City of Portland

Development Review Application
Planning Division Transmittal Form

Project Name: Bay House Phase 2

Address: 101-121 NEWBURY STREET

LEFT SIDE ELEVATION

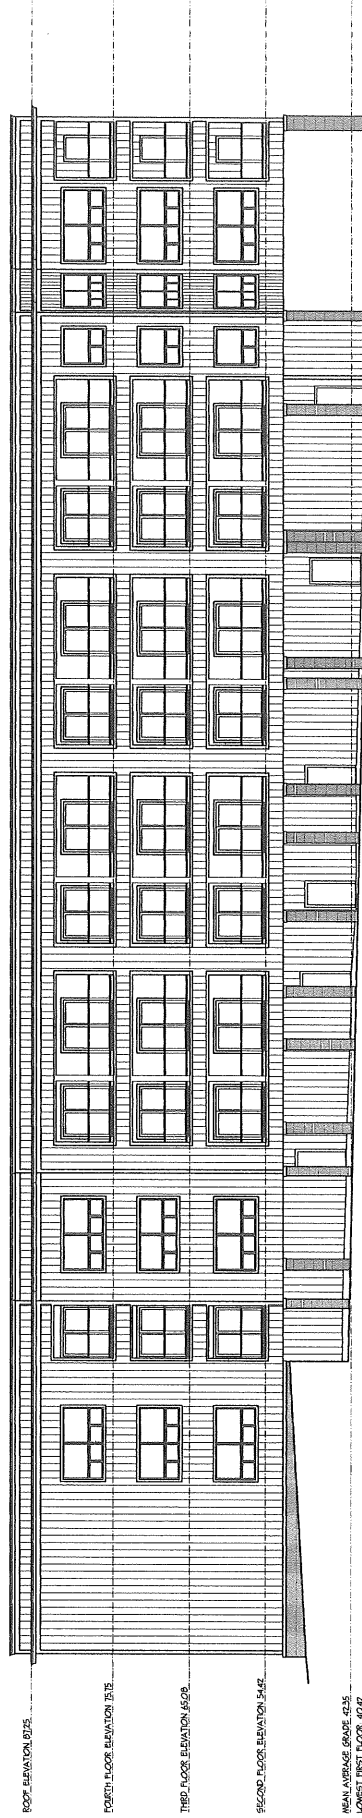
More plans have been submitted showing the average grade and the roof elevation. I would want a little more clarity as to what is being considered as the "roof elevation". The definitions required the height of a building to be measure to the top of the roof beam. Is that where the 87.25 measurement is taken? Also what is above that area? The plans show a higher elevation going around the building. I did not see any plans that explain that level. Is it for sheilding mechanical equipment? The dBA's can be assessed at the time of a building permit for the HVAC systems.

To follow up the 45' maximum height is being exactly met based upon the information received, if the upper roof shown on the plans is for mechanical systems.

We measure the top of the roof to the top of the plywood on the roof trusses, so we are probably on the safe side. The roof slopes to drains, so the measurement would be to the highest location. The parapet that surrounds the roof are is to shield the roof ventilators, the plumbing stacks and the condenser units for each dwelling unit. Also on the roof is the make up air unit which serves the corridors. The elevator hoistway will extend above the roof deck, probably to or slightly above the roof deck. This is allowed by the zoning ordinance. Having the parapet does effectively shield these items from street level as well as any floor height 6' lower than the roof level unless you happen to be on the top floor of the townhouses beyond as they are higher than the roof level. This parapet works the same way as the parapet on the adjoining Bay House project.

SITE SECTION

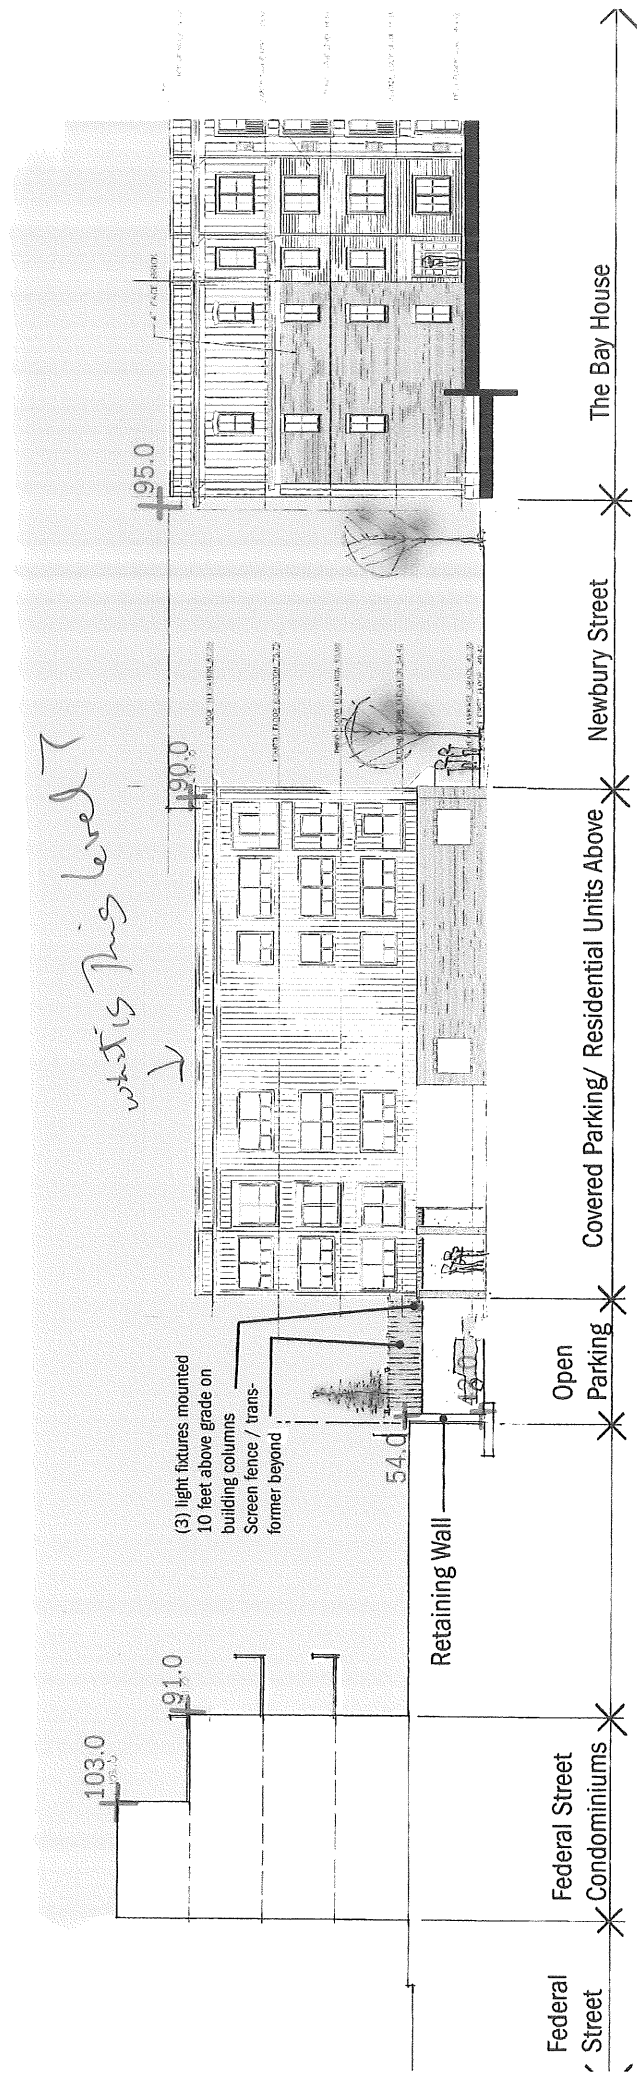
what is this level?

HANCOCK STREET ELEVATION

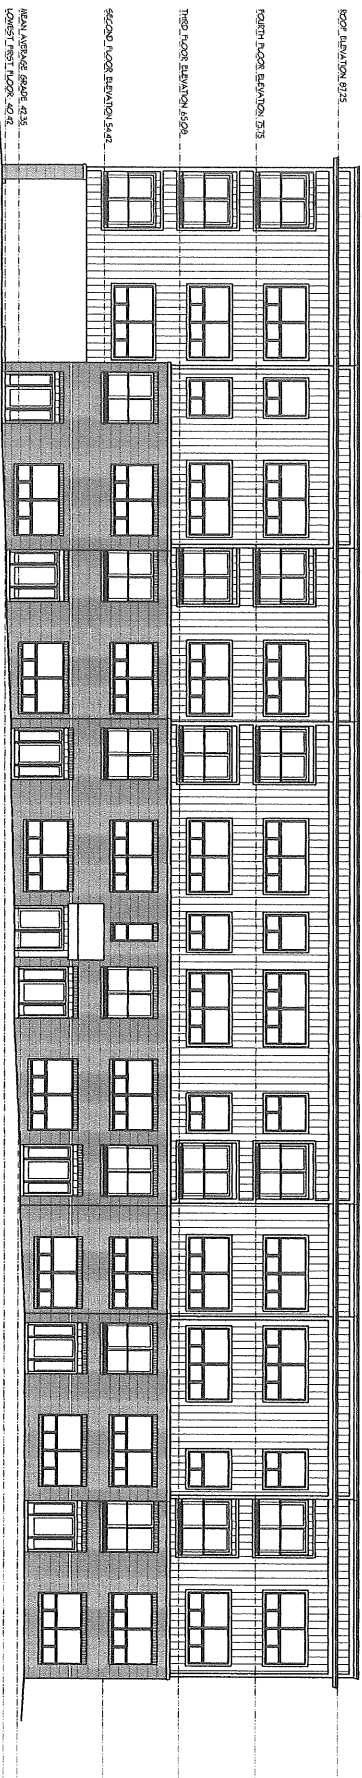
More plans have been submitted showing the average grade and the roof elevation. I would want a little more clarity as to what is being considered as the "roof elevation". The definitions required the height of a building to be measure to the top of the roof beam. Is that where the 87.25 measurement is taken? Also what is above that area? The plans show a higher elevation going around the building. I did not see any plans that explain that level. Is it for sheilding mechanical equipment? The dBA's can be assessed at the time of a building permit for the HVAC systems.

To follow up the 45' maximum height is being exactly met based upon the information received, if the upper roof shown on the plans is for mechanical systems.
